Report No. EGG-EA-5417

Adequacy of Station Electric Distribution System Voltages, Palisades Plant,  
Docket No. 50-255, TAC No. 12780

ADEQUACY OF STATION ELECTRIC DISTRIBUTION SYSTEM VOLTAGES

PALISADES PLANT

PALISADES  
UNIT ONE LINE DIAGRAM  
FIGURE 1

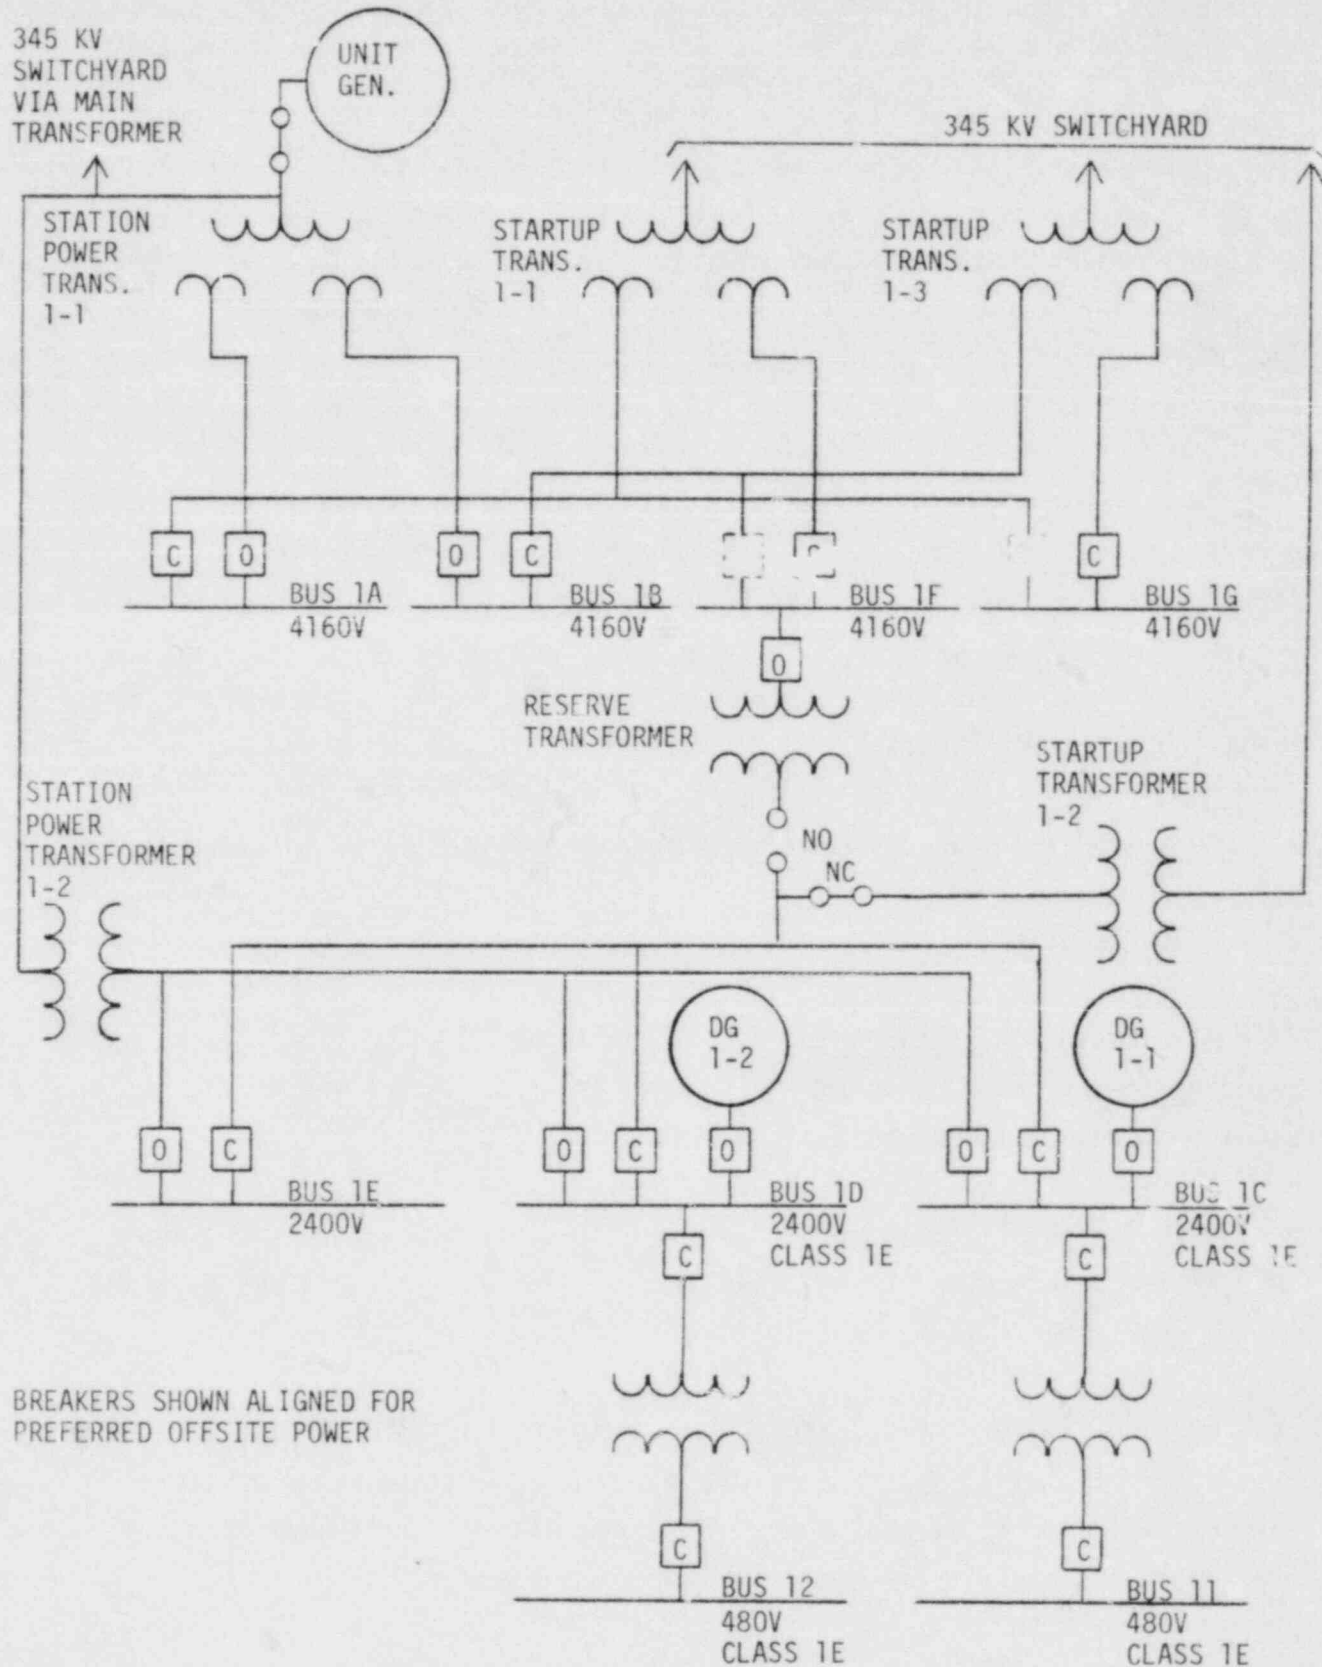
The switchyard that supplies the Palisades Plant is located 0.5 mile away from the unit. All three startup transformers (and, hence, the reserve transformer) are supplied power by a single overhead transmission from the switchyard. The feeder has a single disconnect device (#24R2) and no individual circuit breakers or isolation switches (per Palisades Drawing WD 1421).
